Bulletin: CLIB-0004

Topic: Heavy Duty Clutch Fails to Disengage (Broken Pivot Bolt)

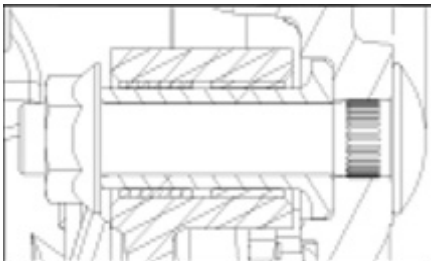
Complaint of transmission will not engage in a gear from neutral and / or truck has urge to move at idle. Clutch data max energy is less than 3000 BTU and no indication of secondary failure. (i.e. FC 16, 35,93). Return material findings, flyweight pivot bolt breaking where the threaded portion of bolt passes through the pivot point.

All future HD DM clutch covers and installations after AU0511160020 serial number will use Robust Pivot Stud System.
